ADDENDUM NO. 2  
TO  
INVITATION FOR BIDS

IFB-16-HHL-007  
INDIVIDUAL WASTEWATER SYSTEM REPLACEMENT,  
LALAMILO PHASE 1, LOT 1

## **ADDENDUM NO. 2**

**Individual Wastewater System Replacement, Lalamilo Phase 1, Lot 1**

Figure 1  
 11  
 Overall Site Plan 08-10-15

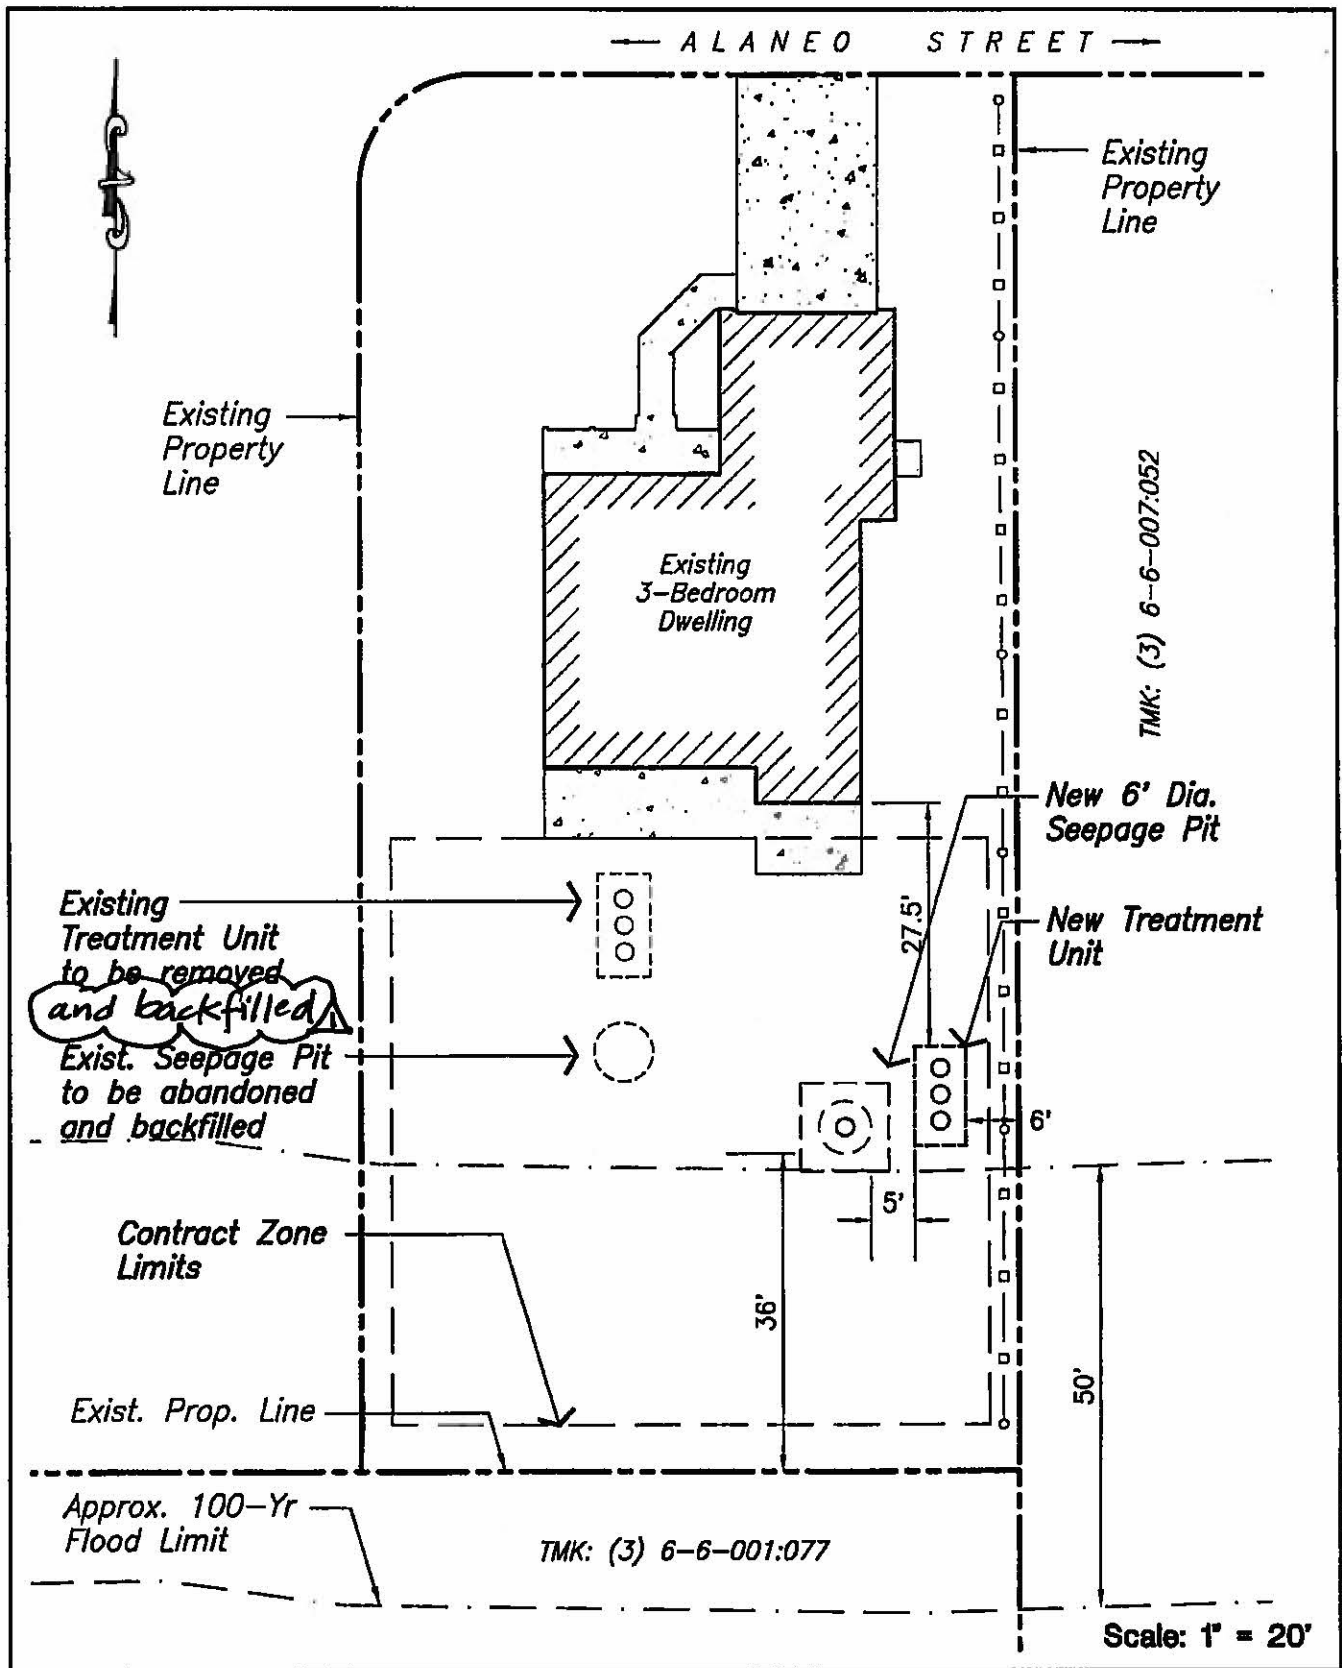
1. 'Overall Site Plan (Figure 1), Rev 11-05-15' provided in Addendum No. 1 shall be replaced with 'Overall Site Plan (Figure 1), Rev 11-10-15'. (Enclosed).

Notes- 1) Existing treatment unit to be removed and backfilled; And,  
2) Existing seepage pit to be abandoned and backfilled.

\*Summary - Existing seepage pit improvements shall no longer be removed as noted in Addendum No. 1, but abandoned and backfilled in accordance with the original plans.
